From: Rodney Hammett
Monday, March 4, 2024 10:19:43 AM
Sent on: DASubmissions
To: Re: D/2024/96 - 6 Forest Street, Forest Lodge
Subject:
Attachments: Ltr to CoS_240304_final.pdf (598.27 KB)

Re: D/2024/96
6 Forest St, Forest Lodge
Objections

6 Forest Street Forest Lodge D/2024/96

Re: D/2024/96 - 6 Forest Street FOREST LODGE NSW 2037

Fig. 1 highlighting mansard roofs in the row of 4 terraces

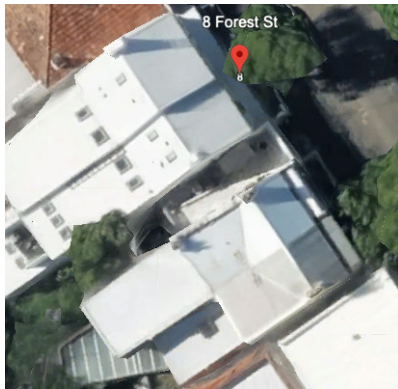
1. 6 Forest St (the **Site**) is one of a pair of matching terraces (4 & 6 Forest St). It is also one of a row of Victorian terraces (4, 6, 8 & 10 Forest St). Each terrace in the row is, according to the SOHI, a contributory item. Among other shared features, each terrace in the row of 4 has timber windows and doors, and corrugated iron Mansard roofs to the front & rear.

2. The proposed development includes a 3-storey addition projecting beyond the streetscape façade building line of the group of 4 terraces and to the maximum height of the original building. It would be a significant interruption to the row of contributory items. And it would not meet various objectives for the HCA, including those in the State government's 2011 *Guidelines for Infill Development in the Historic Environment* and the Council's own *Heritage Inventory Assessment Report*. Critically, it would set a precedent for development that would detract from the heritage values in the HCA.

Fig. 9 Demolition of portions of the garage and landscaping to the rear of the Site

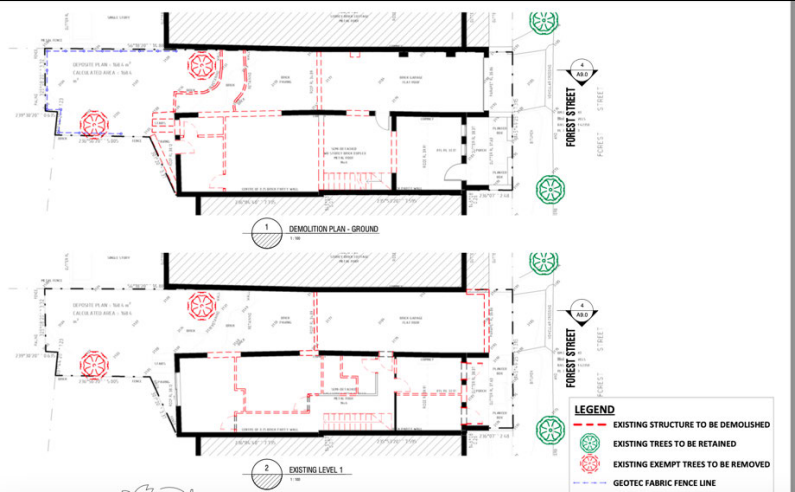
- The garage has been poorly built. This is evident in water penetration at 8 Forest St seen on images from the [SOHI](#). Water penetration at either end of the garage. This is also evident as the [driveway is uneven](#) and encroaches onto the pedestrian footpath.
- The building line of the garage does not respect the building line of the facades of the group of contributory items: the row of 4 terraces.

- a pre-demolition/excavation dilapidation report;
- a *works as executed* dilapidation report; and
- a *works as executed* survey.

Fig. 14 The proposed addition (streetscape and rear)

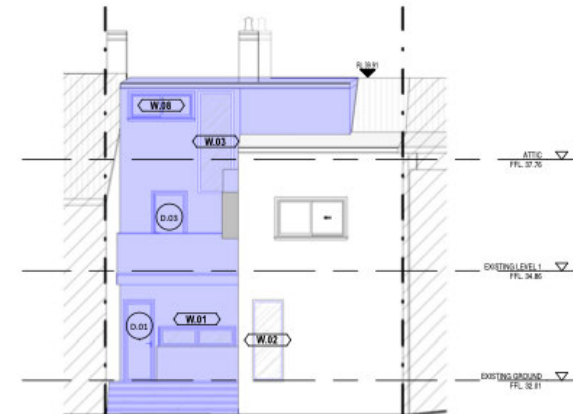
Q	<p>§6.2(2) <i>Additions should maintain the integrity of the profile and form of the original building, including the roof form and profile and allow the original building to be discerned</i></p> <p>§6.2(3) <i>Additions are to be smaller in height and scale than the existing building</i></p>	<p>The proposed additions do not maintain the integrity of the profile and form of the original building, including the roof form and profile.</p> <ul style="list-style-type: none"> ▪ The original roof form and profile will not be discernible when viewed from the west (from 8 Forest St.) or from the rear. ▪ The integrity of the profile and form of the original building will not be maintained by the proposed 3-storey addition to the rear.

The proposed additions are not smaller in height and scale than the existing building.

Below are the available images of the proposed addition and extension from the front and rear. The SW elevation does not articulate what the rear will look like. It does, however, provide height and scale impressions.

Figure 4 The form of the dormer, the use of aluminium windows, the design of the balcony door and the door leaf for the ground floor are unsympathetic.

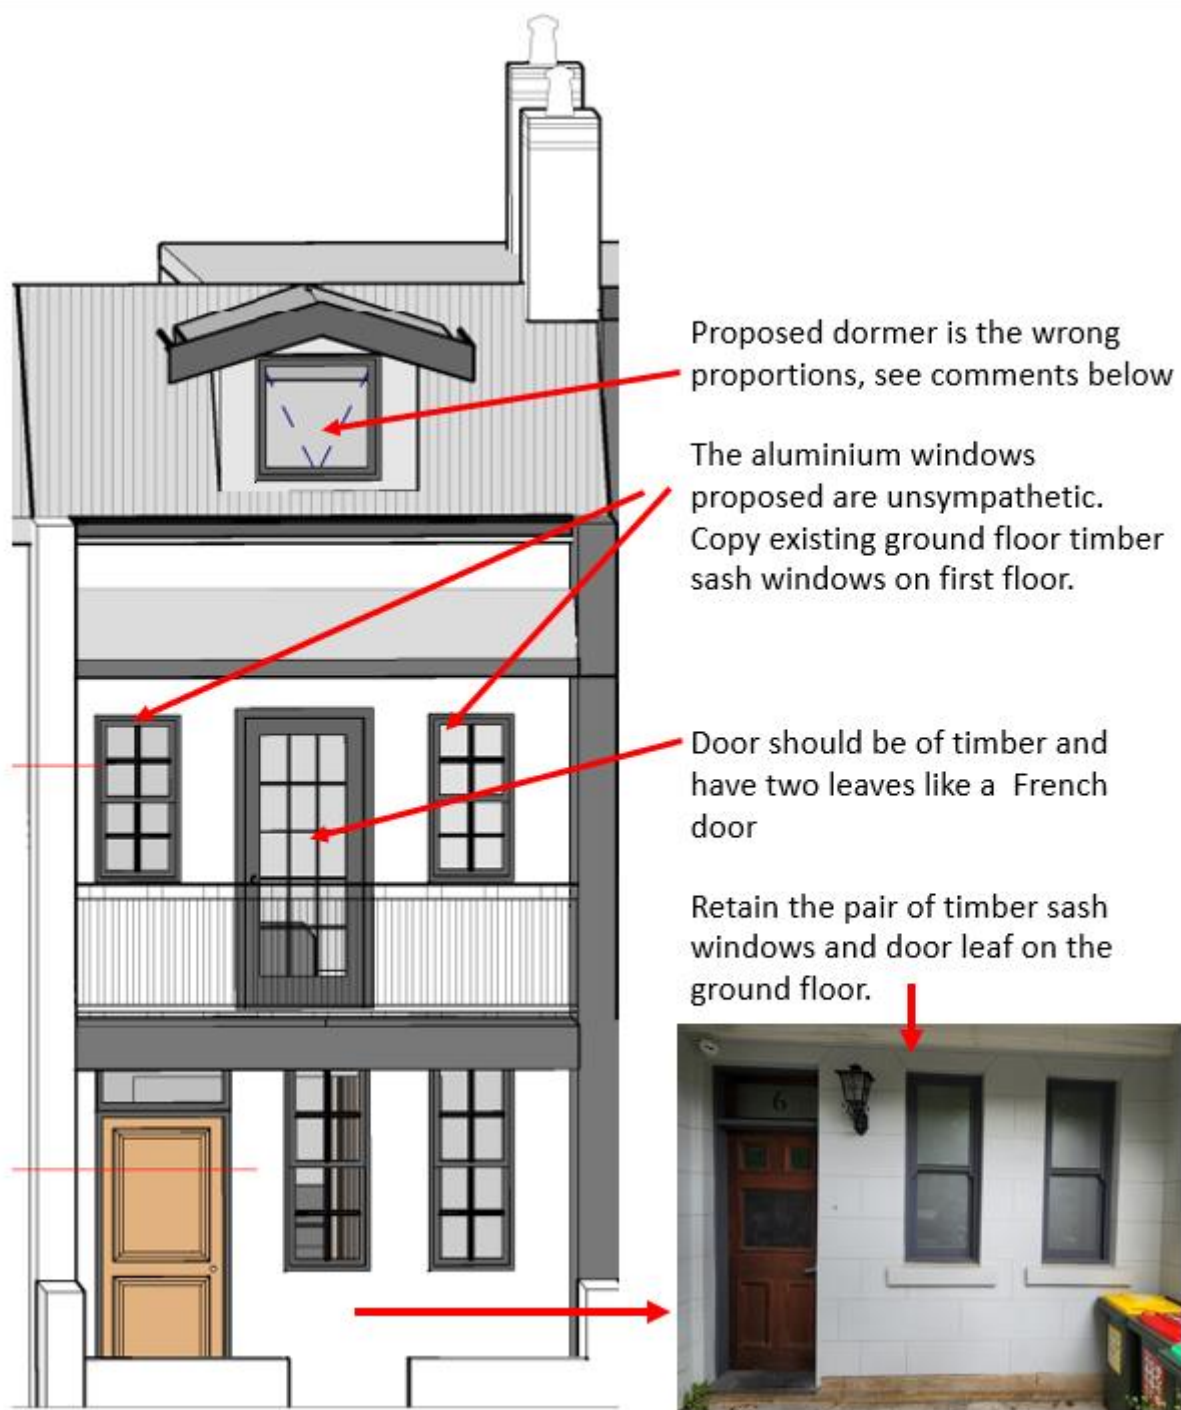
Figure 4 below shows why the proposed changes to the façade of 6 Forest Street are contrary to the principles of the 2012 DCP and the management principles of the Heritage and Forest Lodge HCA.

- I. The design and materials (aluminium with imitation glazing bars) of the first floor windows W.06 and W.07 and door D.04 is inappropriate.
- II. The design of the dormer window on the front elevation is incorrectly proportioned, over scaled and unsympathetic

Figure 5 The proposed dormer

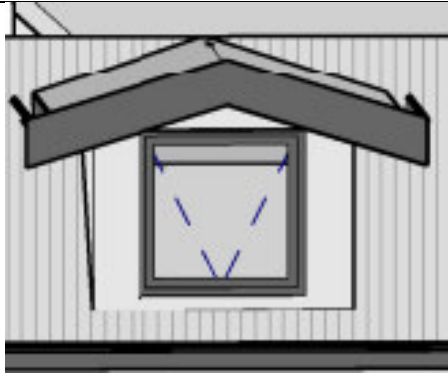
The management principles in the Heritage Inventory Report for the HCA are quite categorical that there be no *visible additions that impact on the existing character* - *No dormers to street frontage*.

The dormer proposed is unsympathetic both in its form and the type of window itself. Figure 6 is an exemplar for a dormer design from the City of Sydney 2006 DCP. The constrained roof space in the case of number 6 Forest Street may not allow for a gabled dormer but other nineteenth century variants may work such as the dormer with a curved iron roof shown in fig 7 or the early colonial example of a small dormer shown in figure 8.

Figure 15 The proposed rear elevation.

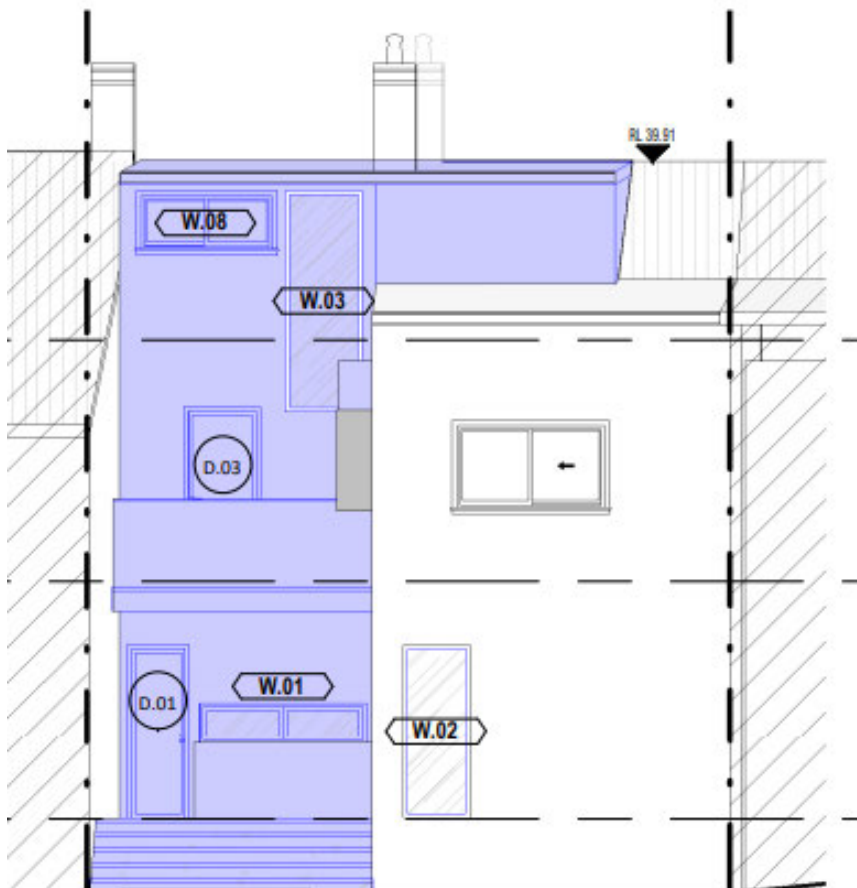
The proposed rear elevation is obtrusive. The fenestration with its vertical aluminium sliding windows is incongruous and the rear dormers do not maintain enough legibility of the roof. The attics need to be set in by a minimum of 500mm from side walls and be 200mm below the ridge line.

- V. The infill/extension building should have a pitched roof
- VI. The elevations of the extension facing the back yard is crudely designed, bulky and has unsympathetic fenestration.

- VII. The rear attic roof should be lower than the ridge line and should be inset 500mm from the side walls.
